SIB 64 08 26

EVAPORATOR CONDENSATE DRAIN COMES LOOSE

2026-08-28

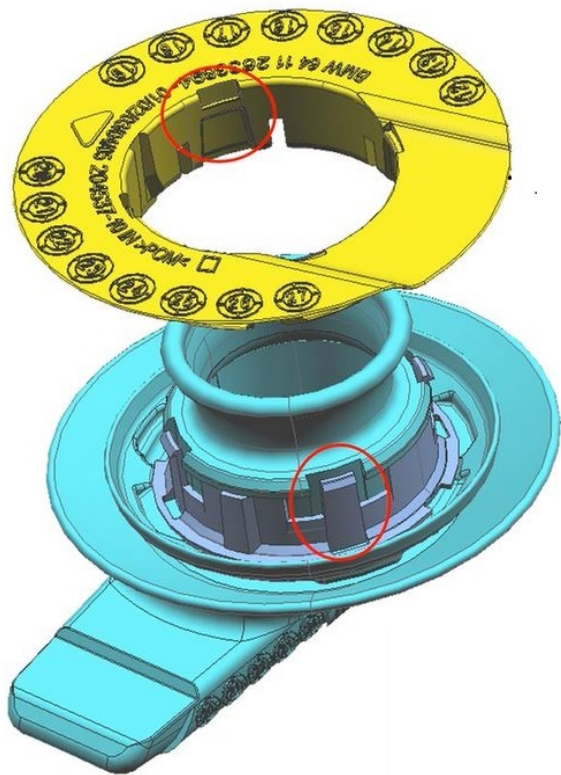
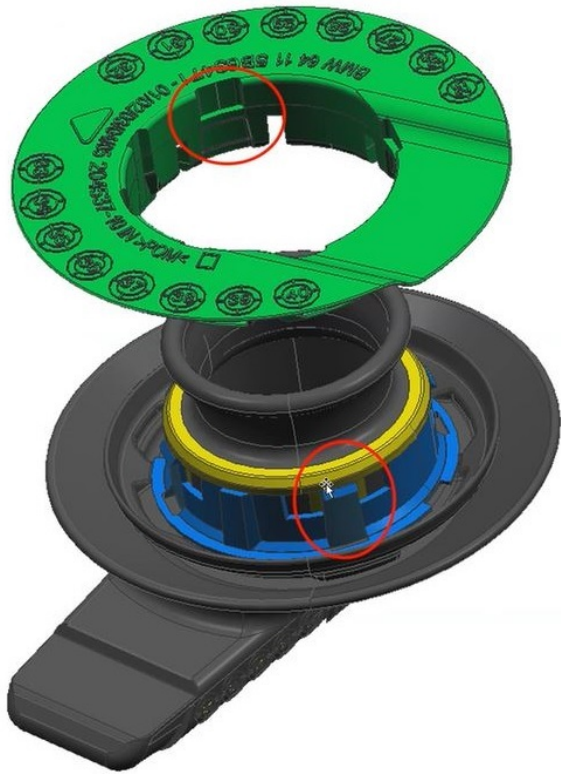
The two-piece evaporator condensation drain was not fully locked together (lock tab circled in red) when assembled and has come apart. Its lower half can thereby bounce around under the vehicle.

NOTE: Both halves of the evaporator condensation drain were redesigned.

Used in vehicles produced **UP TO** February 28, 2025. The clip locations circled in red indicate the design change.

Used in vehicles produced **FROM** February 28, 2025. The clip locations circled in red indicate the design change.

The updated parts are installed in vehicles produced FROM February 28, 2025.

When replacing the lower half of the 'condensation water drain' it must match the production date of the upper retaining ring for condensate'. See ETK page 64_2843 for your specific vehicle. You must use the old upper and lower together, or the new upper and lower together; don't mix parts!
